NEW ELEMENTARY AND MIDDLE SCHOOL

CONTENTS - VOLUME TWO

phase	Bid Package No. 2
date	January 3, 2008
ADD	October 17, 2007
ADD	October 26, 2007
ADD	November 2, 2007
ADD	November 5, 2007

project # 06022

Signal Plan
Sector 'B'

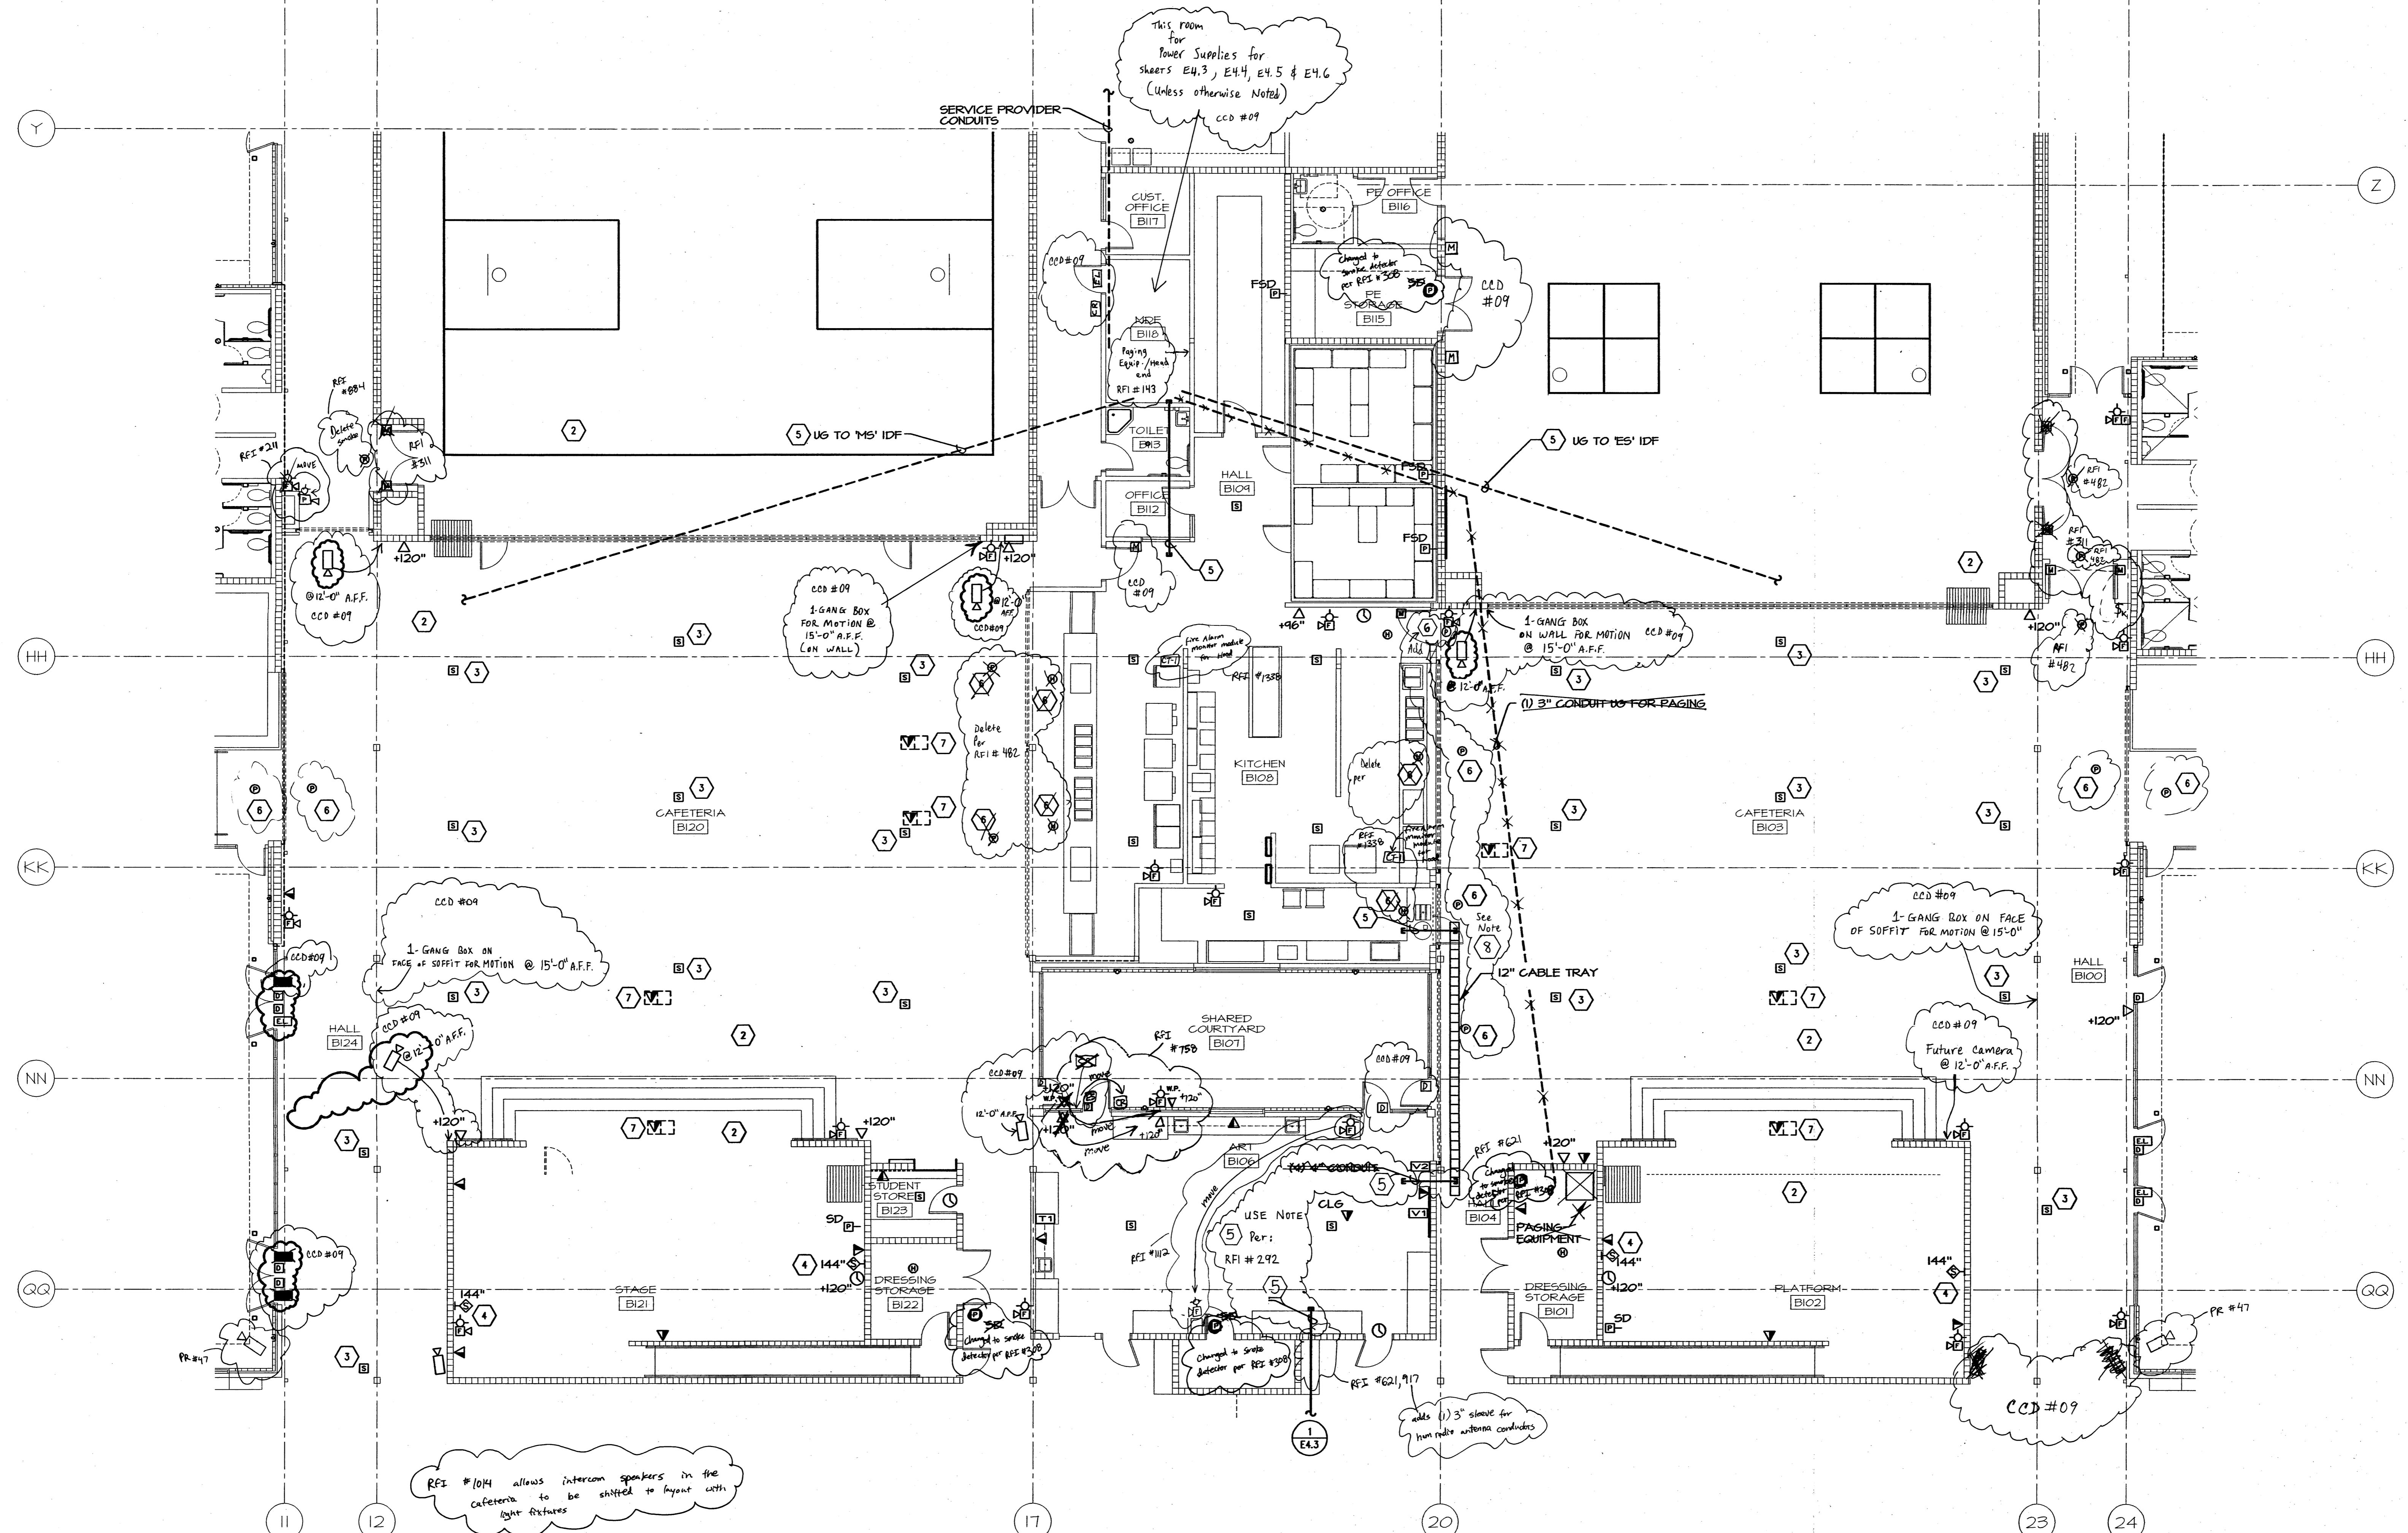
- PROVIDE MANUFACTURER RECOMMENDED WIREGUARD.
- SEE SHEET S511 FOR ADDITIONAL CONDUITS AND BACK BOXES REQUIRED IN THIS SPACE.
- SPEAKER MNT'D TO BOTTOM OF ACOUSTIC ROOF DECK WITH A METAL ENCLOSURE.
- MOUNT SPEAKER IN A METAL ANGLED ENCLOSURE.
- (4) 4" CONDUIT TO FOR V/D
(1) 3" CONDUIT FOR PAGING
(1) 3" CONDUIT TO FOR FIRE ALARM
(1) 3" CONDUIT FOR FUTURE CCTV
- DETECTOR FOR DROP DOWN FIRE DOOR. *Mount here if General Alarm not trouble* RFI # 351
- PROVIDE 1" CONDUIT TO ACCESSIBLE CEILING SPACE. COORDINATE WITH ELECTRICAL PLANS FOR FLOOR BOX TYPE AND LOCATION.
- RACE PHOTOELECTRIC DETECTORS ON THE UNDERSIDE OF SOFFIT OVER THE FIRE SHUTTERS. RFI # 482

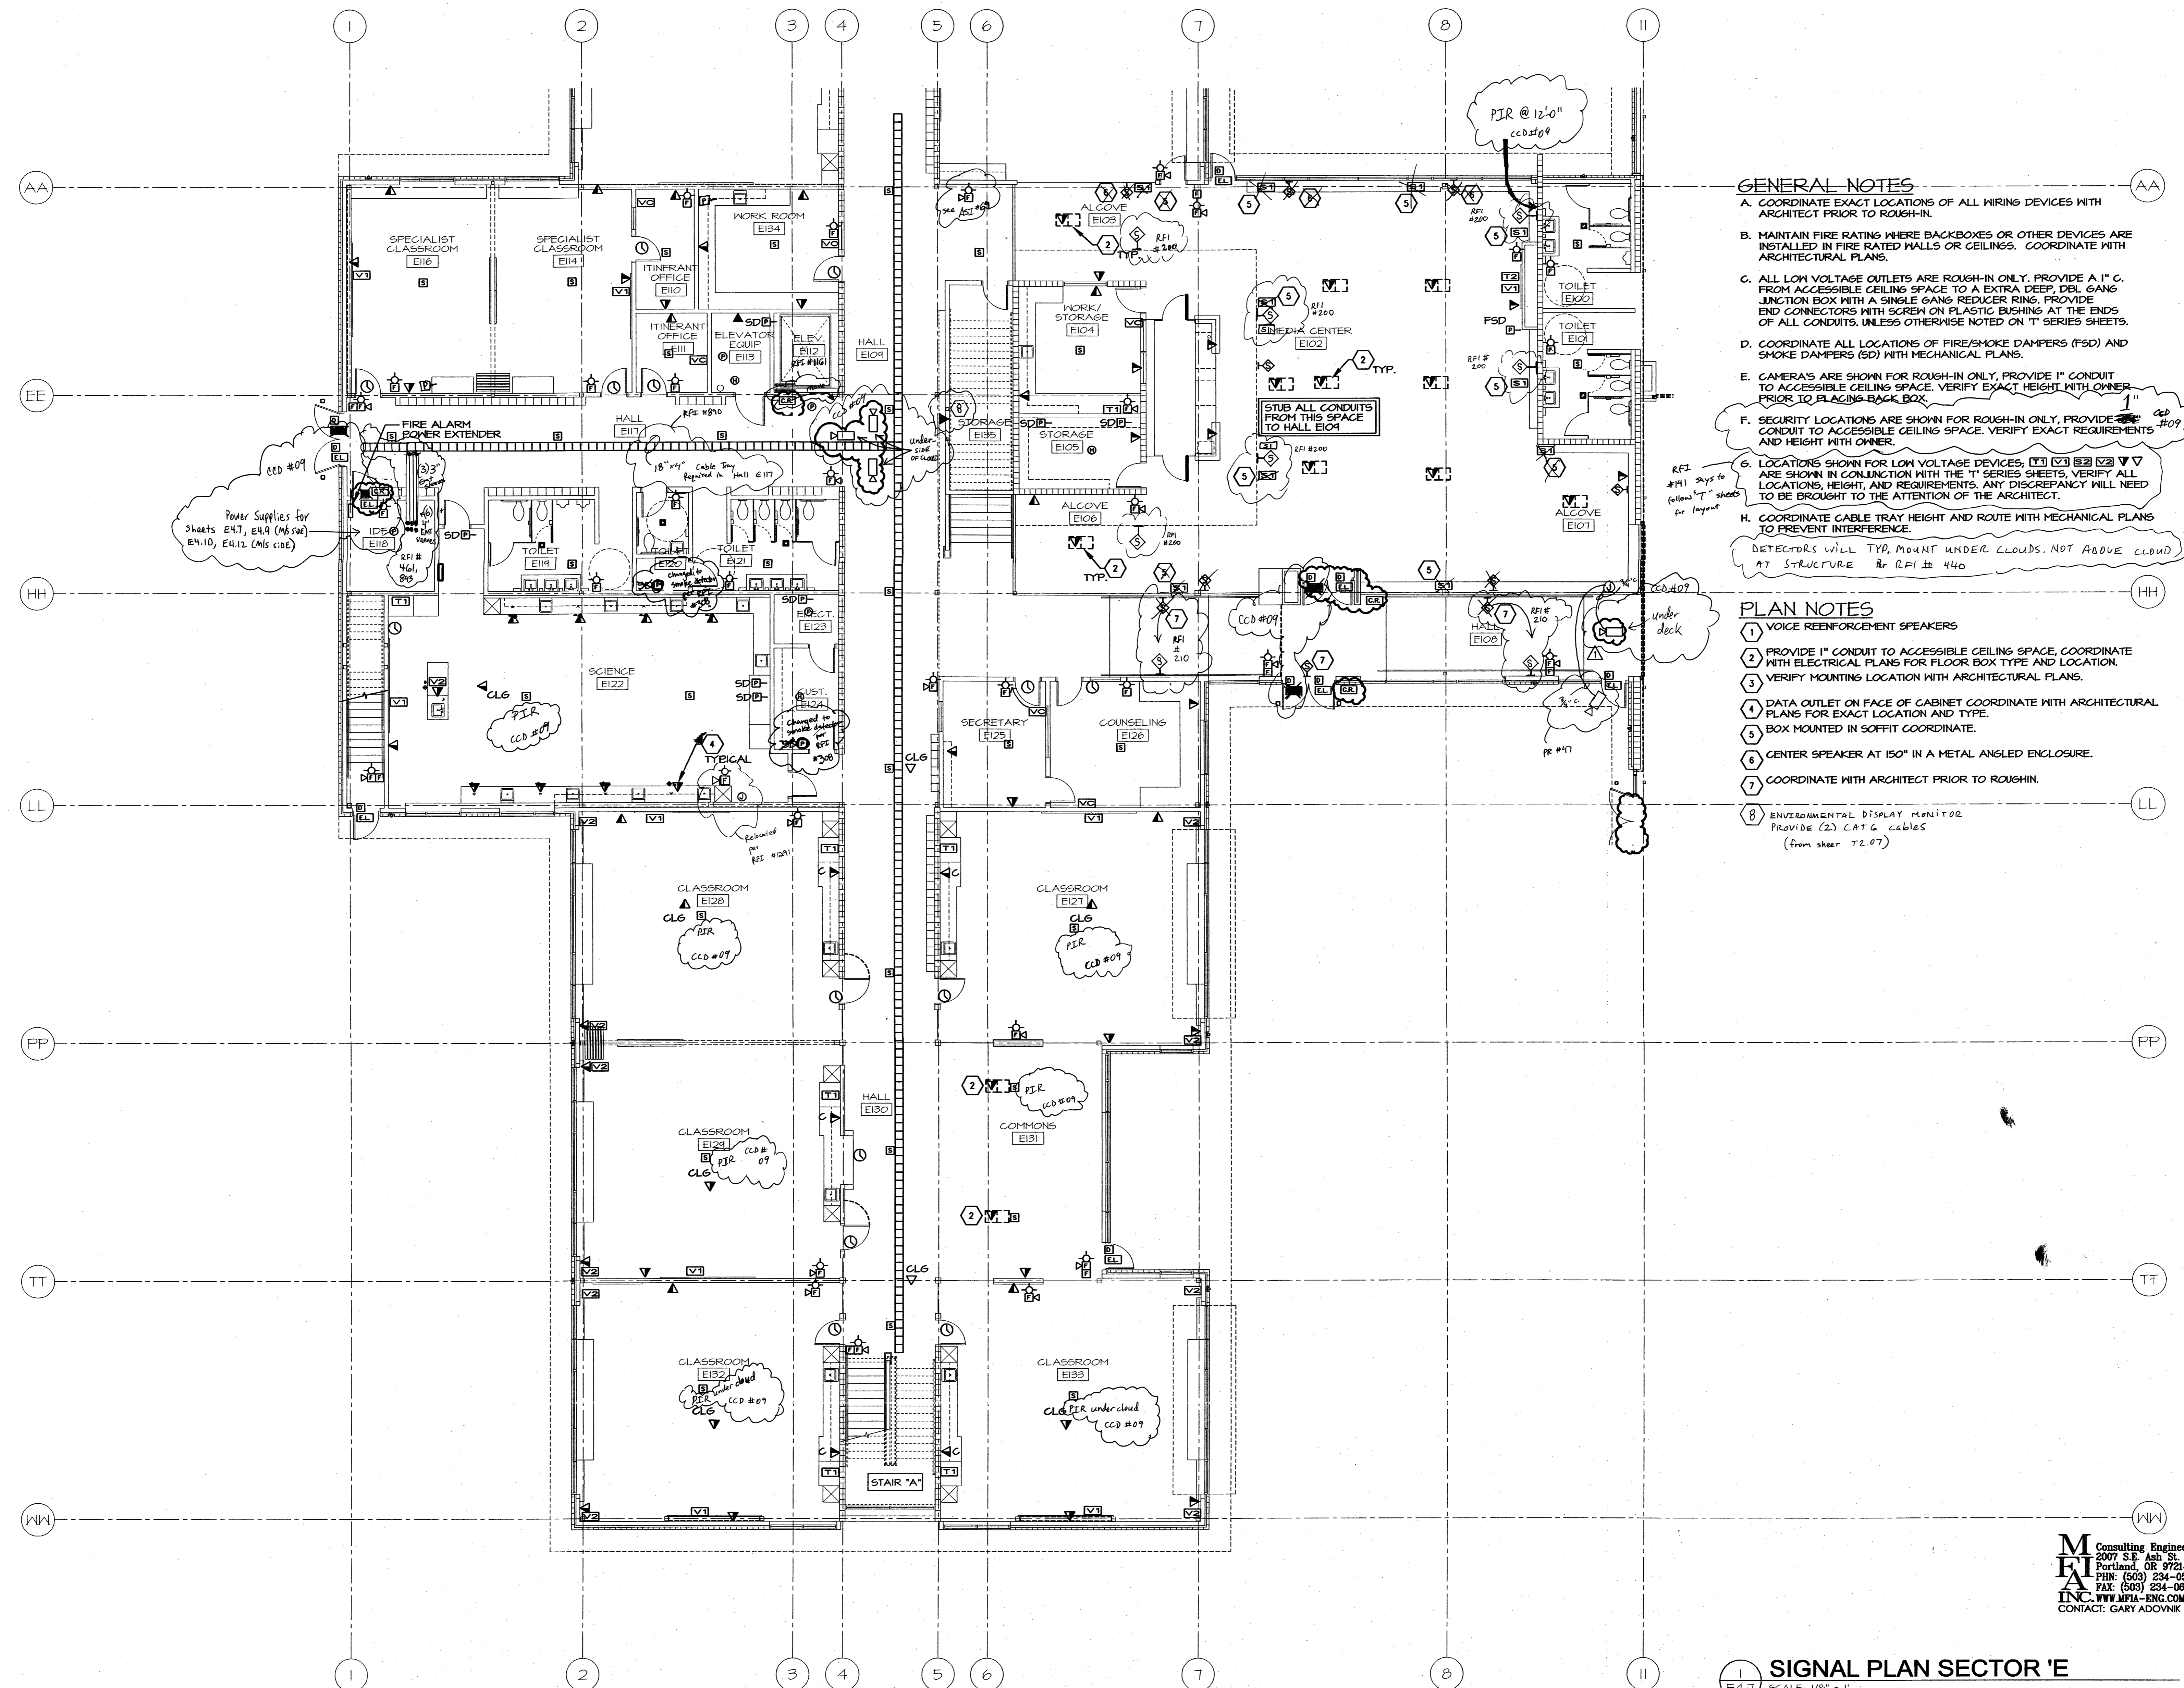
DETECTORS WILL TYP. MOUNT UNDER CLOUD. NOT ABOVE STRUCTURE PER RFI # 440
